CITY COUNCIL AGENDA ITEM

Subject: PUBLIC HEARING – PRELIMINARY SITE PLAN REVIEW (SP JPLN2021-0028) - Proposed Golden Villas One Family Residential Cluster, South side of Square Lake, West of Dequindre (PIN 88-20-12-200-031 & 88-20-12-200-035), Section 12, Currently Zoned R-1C (One Family Residential) District

Preliminary Site Condominium Cluster Review For City of Troy, Michigan

Project Name:	Golden Villas
Plan Date:	February 28, 2022
Location:	South of E. Square Lake, west of Dequindre
Zoning:	R-1C, One-family Residential District
Action Requested:	Preliminary Site Condominium Cluster Approval
Required Information:	Deficiencies noted.

DRAWING TITLE
PRELIMINARY SITE PLAN

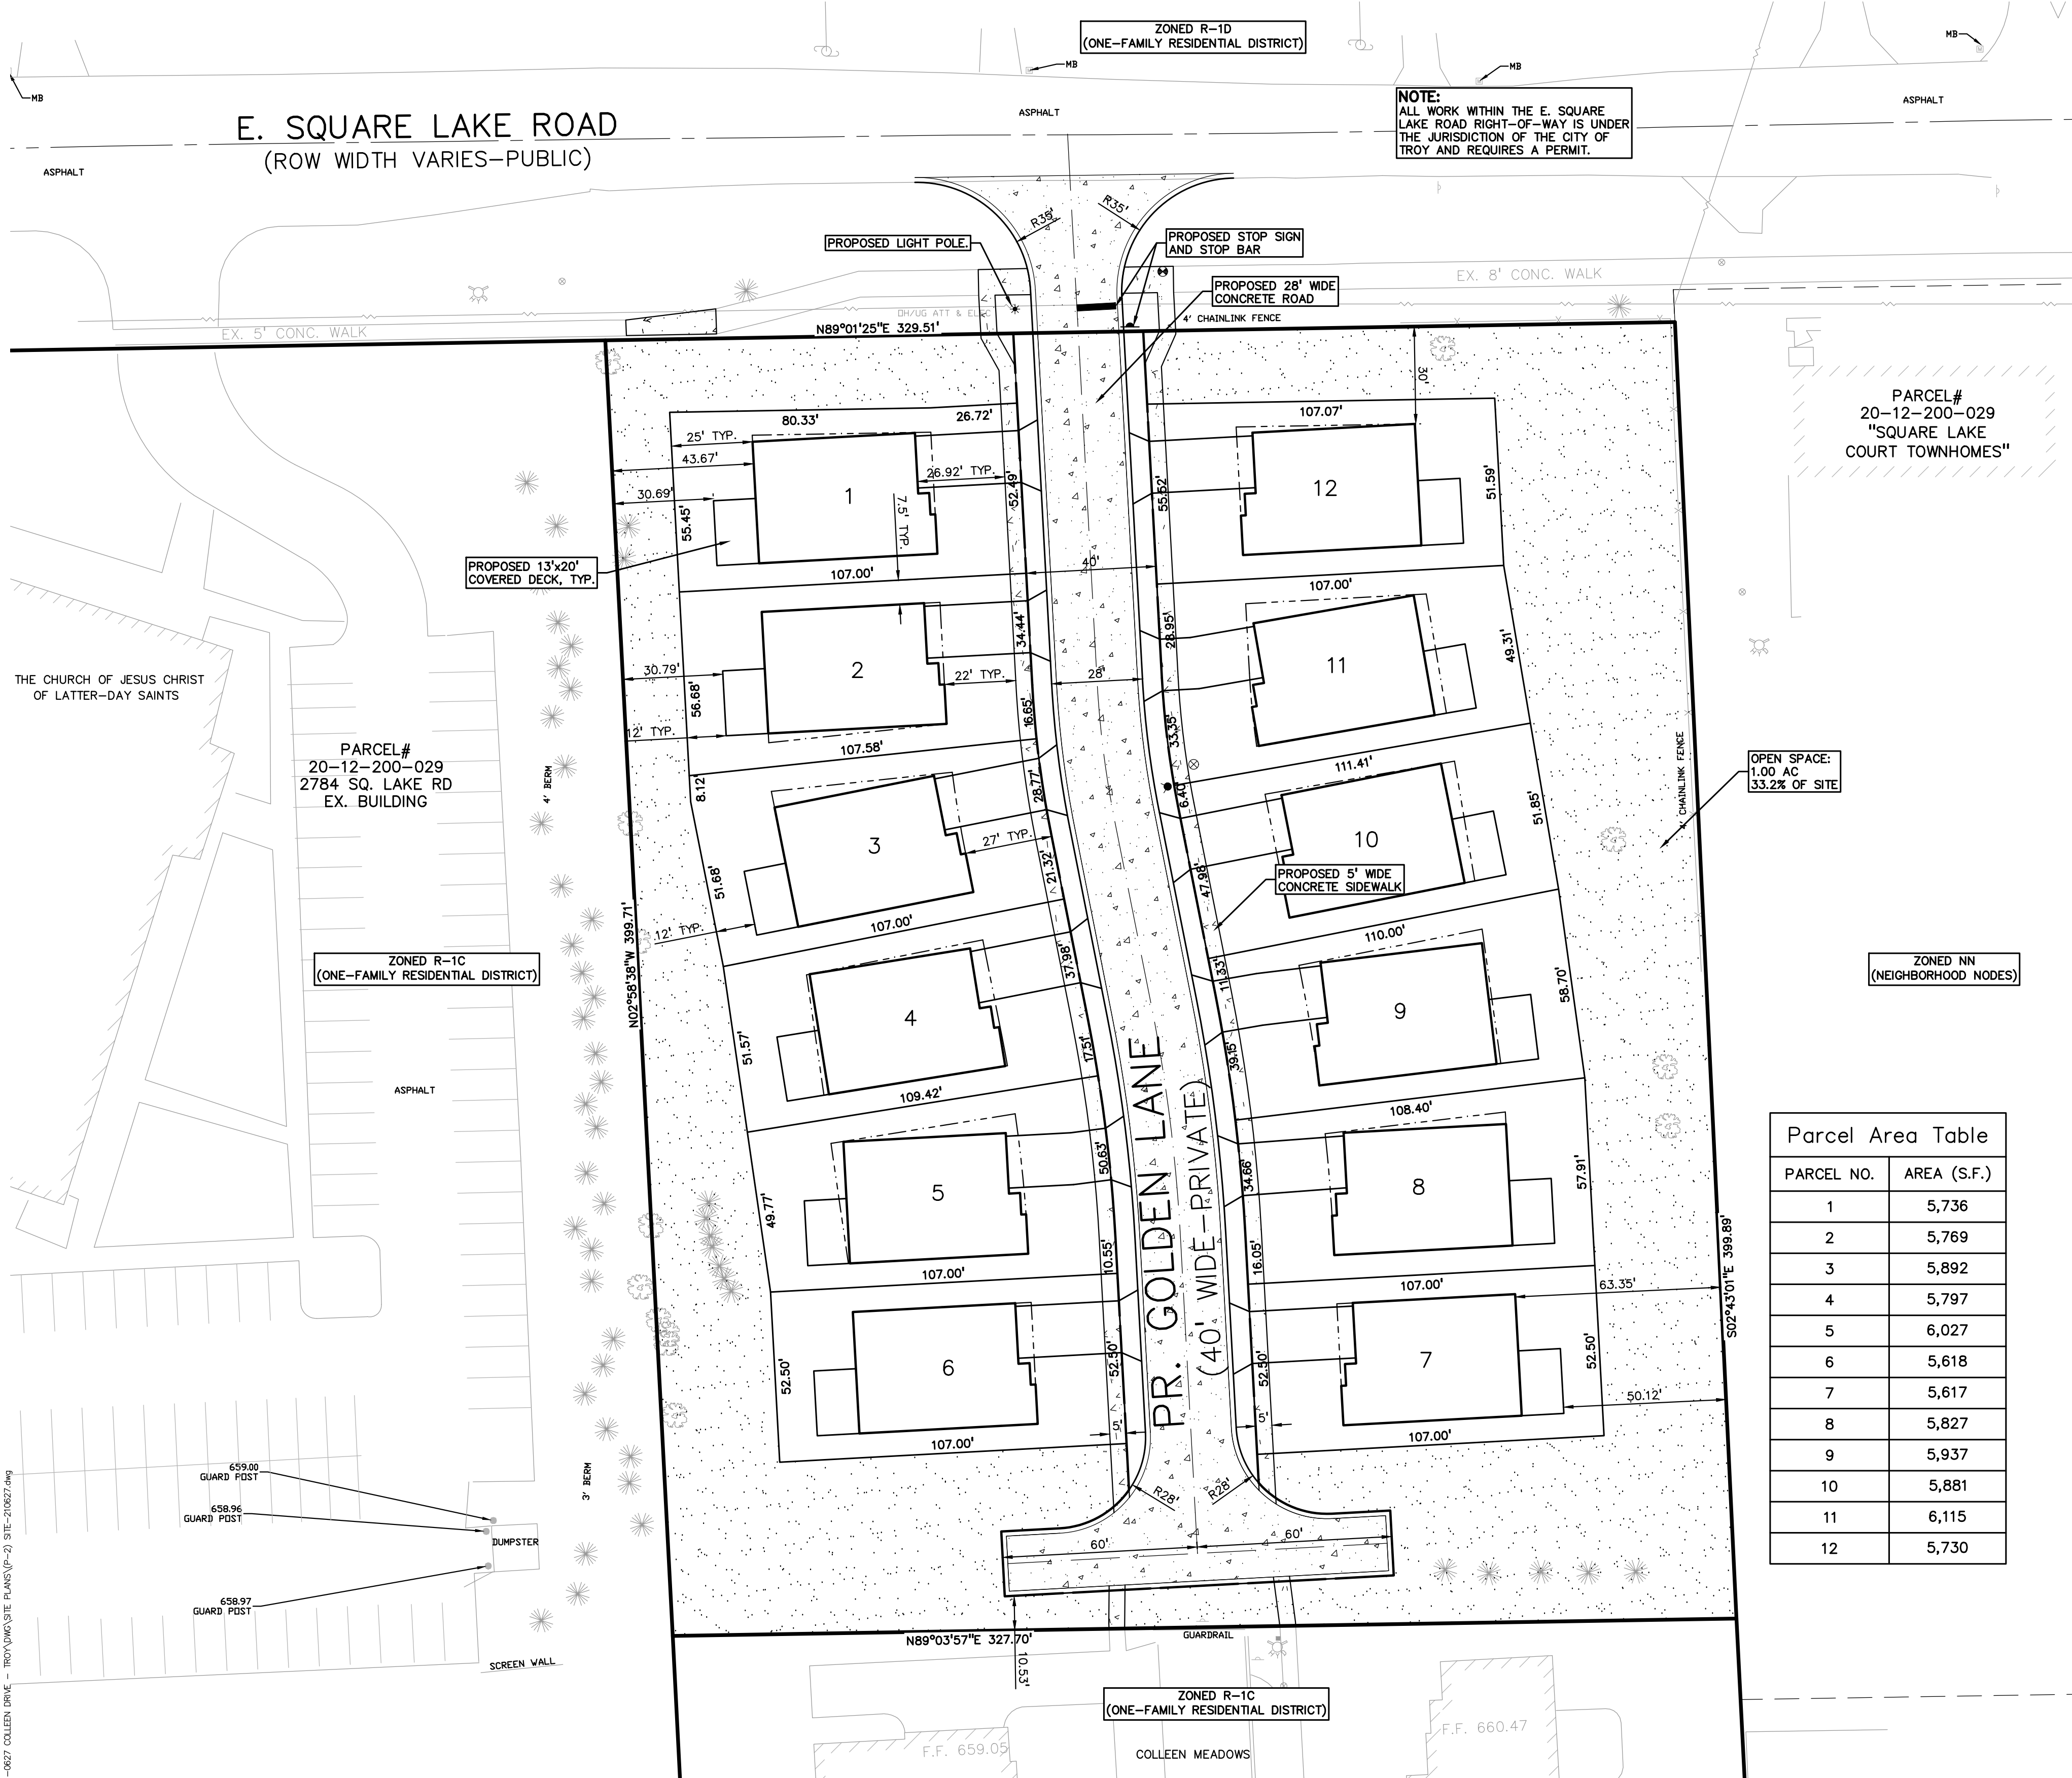
Rear Setback (building)	25-feet setback	25-feet minimum 10-feet with deck	Building envelopes comply. All decks encroach 15-feet into required rear yard. Applicant seeking relief to have minimum rear yard less than 25-feet due to deck.
Side Setback (building)	7.5-feet setback	7.5-feet minimum	Complies
Open Space Requirements: Minimum Percentage	20%	Proposing to preserve 1 acre of the 3 acre parcel, or 33%, for open space.	Complies. Applicant must submit open space preservation covenant.

Lots 1-3 encroach up to 10-feet into the required 40-foot perimeter setback. In addition, all decks extend 15-feet from home and encroach 15-feet into the required 25-foot rear yard. Please note that provision 7.08.B was drafted for a conventional R 1 through R-5 lot that requires a 40-foot setback. Hence for a typical R-lot, the 40-foot rear yard requirement would allow a 15-foot deck and still maintain at least a 25-foot rear yard setback. However, due to the required additional perimeter setback required by the cluster provisions, the decks are further away from the northern property line via cluster than conventional layout.

Items to be addressed: Consider the deck encroachment into rear setback and perimeter buffer

BE IT FURTHER RESOLVED, The Planning Commission recommends approval of granting relief from the required rear yard setback and required perimeter setback as per Section 10.04.E.5, as outlined in the report.

**PRELIMINARY
LANDSCAPE
PLAN**

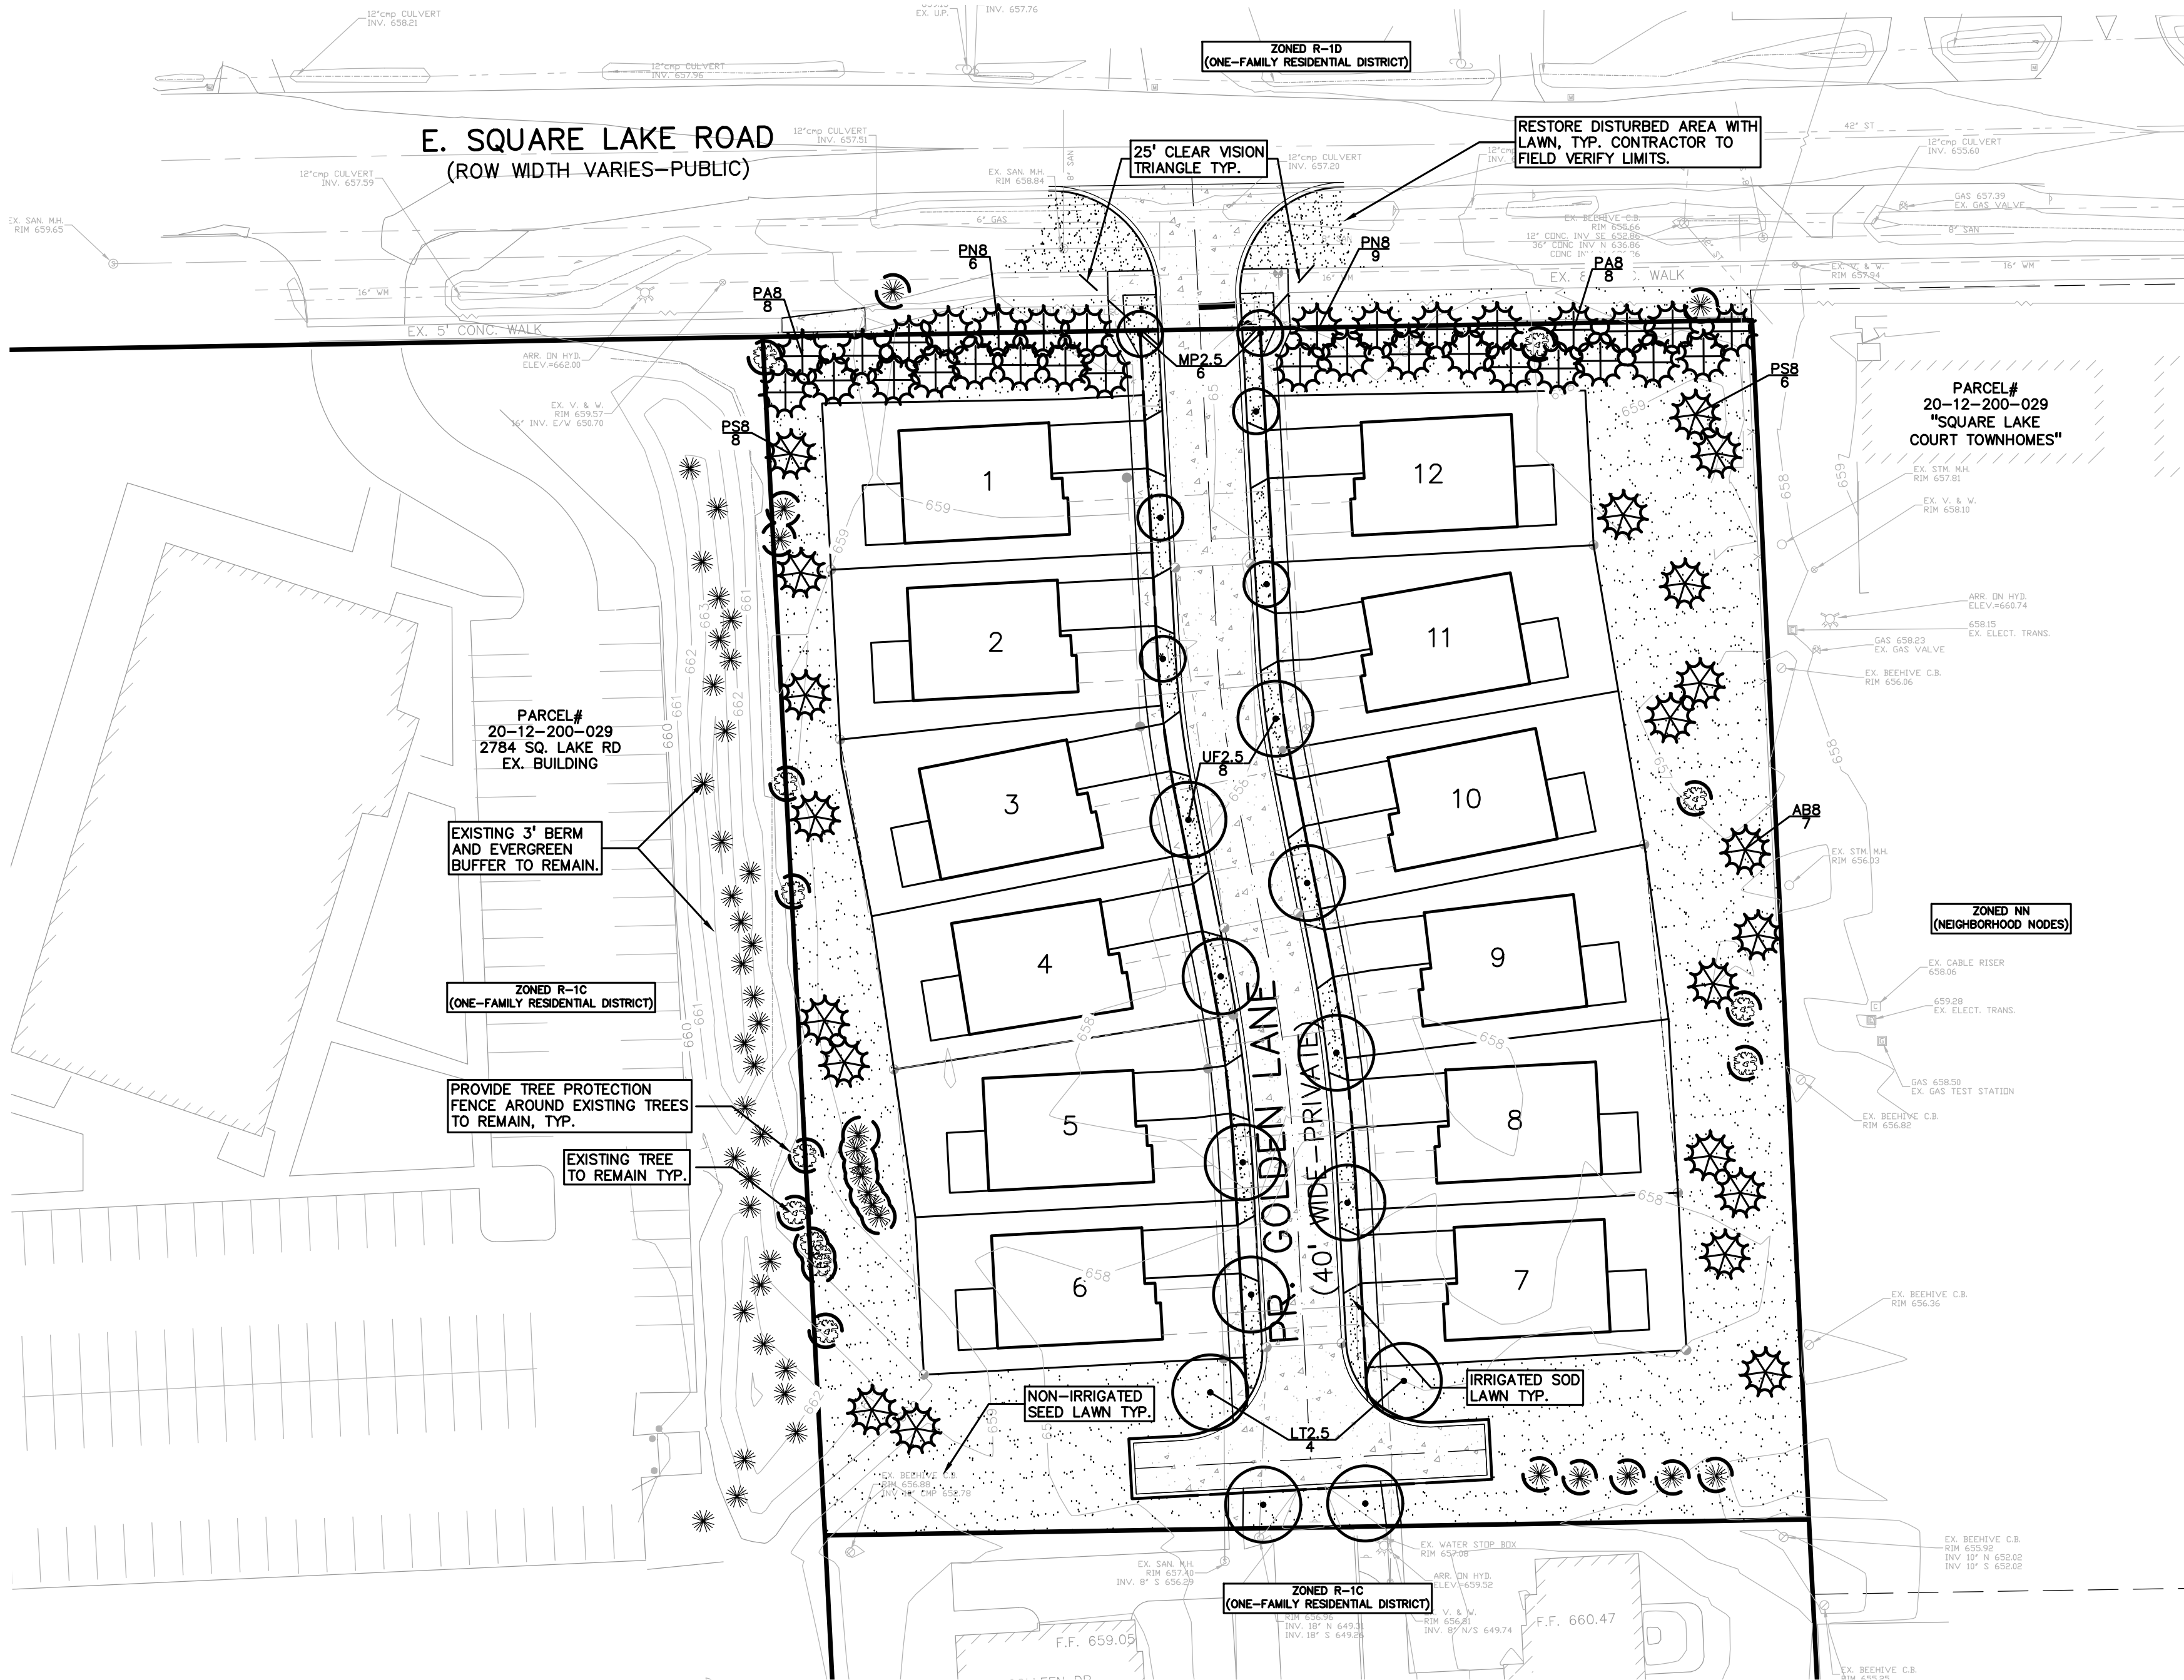
Frontage	Required	Provided	Compliance
Proposed Private Rd.	One (1) deciduous tree for every 50 lineal feet. $890 / 50 = 18$ trees	18 trees	Complies
E. Square Lake Road 120-foot ROW (section 13.02 F.2.c)	One (1) large evergreen tree per ten (10) lineal feet. $329 \text{ lf} / 10 \text{ lf} = 33$ evergreen trees	13 proposed	Does not Complies

The applicant is deficient of twenty (20) trees along Square Lake.

Items to be Addressed: Provide twenty (20) additional trees along Square Lake Road.

The petitioner submitted a Landscape Plan with the additional twenty (20) trees along Square Lake Road. The petitioner has provided numerous additional housing elevation options which were included with the site plan. The petitioner has agreed that the exterior elevations will not include vinyl siding. An Open Space Preservation Agreement will be required to be submitted and approved prior to Final Site Plan Approval.
